SUBJECT: Docket No. 50-602, Request for Renewal of Facility Operating License R-129

REF: UNIVERSITY OF TEXAS AT AUSTIN - REQUEST FOR ADDITIONAL INFORMATION REGARDING THE
LICENSE RENEWAL REQUEST FOR THE NUCLEAR ENGINEERING TEACHING LABORATORY TRIGA
MARK II NUCLEAR RESEARCH REACTOR (TAC NO. ME7694)

**ATTACHMENT 1:
REPORT ON NEUTRONIC ANALYSIS FOR THE UT TRIGA REACTOR**

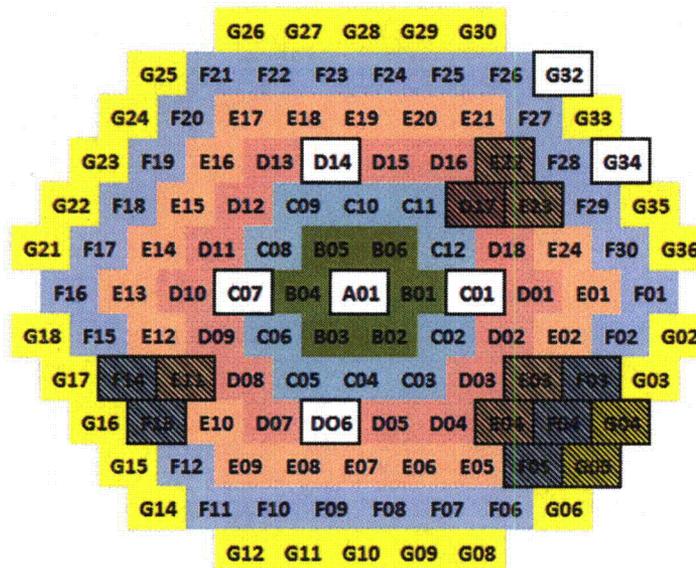
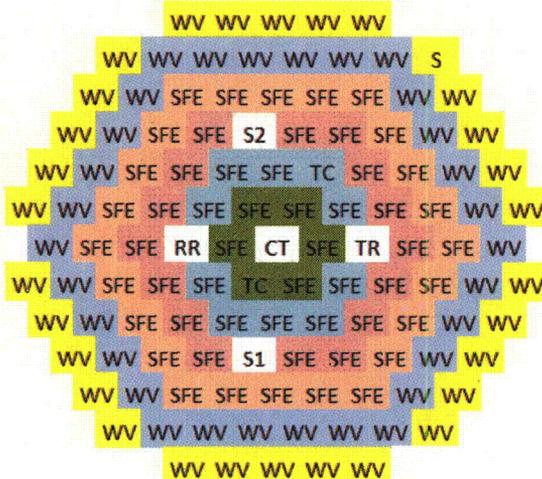
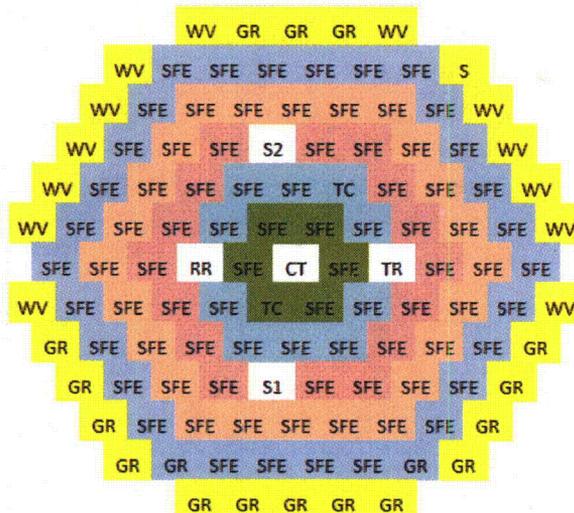
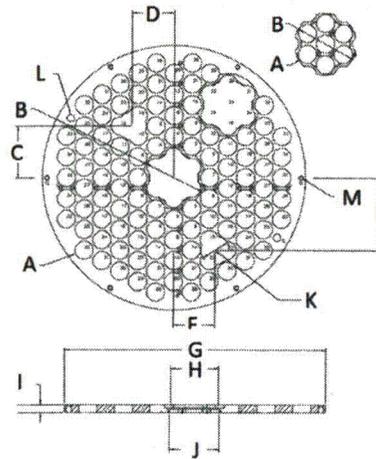
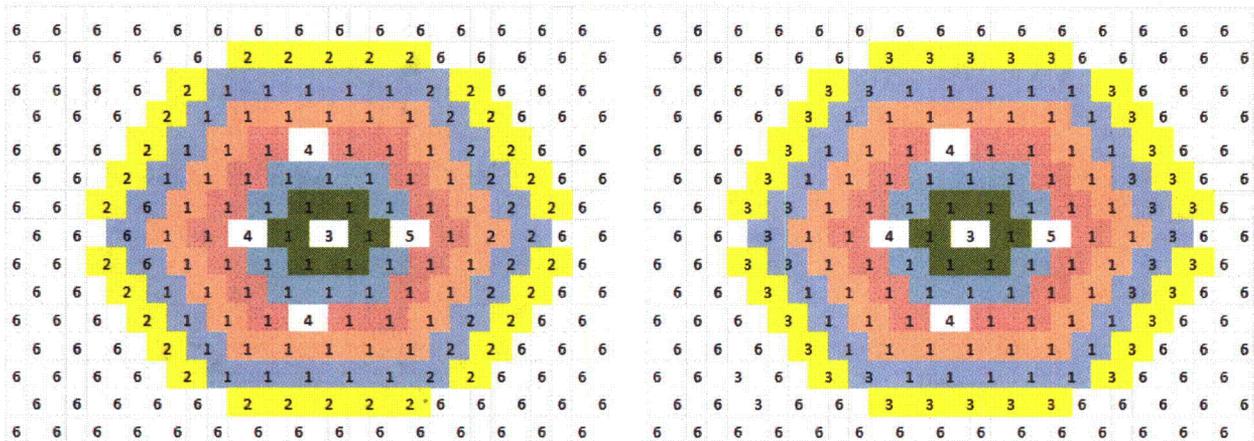
RAI 8.1: UT SAR Section 4.5.1 discusses an "operational core of 85 fuel elements, 3 fuel followed control rods, and one air followed control rod is to be arranged in 5 rings." The NRC staff notes that elsewhere in the UT SAR, references are made to core configurations of 90 (page 4-36), 116 (page 4-55), 109 and 114 (page 4-57), 81 (page 13-7), 83 (page 13-2), 85 (pages 13-26 and 13-29), and 100 (page 13-33) fuel elements. For the UT TRIGA licensed power of 1,100 kW, please identify the LCC. Please provide schematic drawings showing the location of fuel elements, control rods, and other components installed in the lettered-and-numbered lattice positions. For fuel elements provide a cross reference to fuel element serial numbers and their accumulated burnup. Please provide all technical parameters and conclusions supplied for normal operation, accident analysis, and dose estimates using the LCC.

Schematics showing the location of core components are provided in Figs. 1-6, and 15 of Attachment 1. The LCC analysis assumes fresh fuel, and does not assume specific elements or burnup for initial operation. Burnup is discussed for the 1992 core in Sections 1.3 and 6.7, and illustrated on Fig. 3.

Figure 19, Element Radial Peaking factor

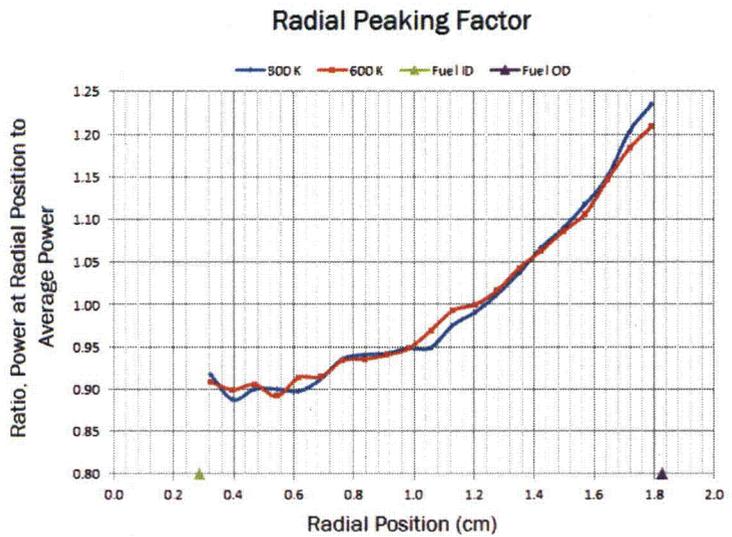
RAI 12: UT SAR Section 4.5.4, Subsection B provides Figure 4.22 for the power within a fuel element. The NRC staff notes that the power distribution in the figure continues to the center of the fuel element indicating that this curve is not applicable to stainless steel-clad fuel that has a zirc rod in the center. Please confirm and revise accordingly.

Updated power distribution analysis is reported in in Section 5.2.2 of Attachment 1.
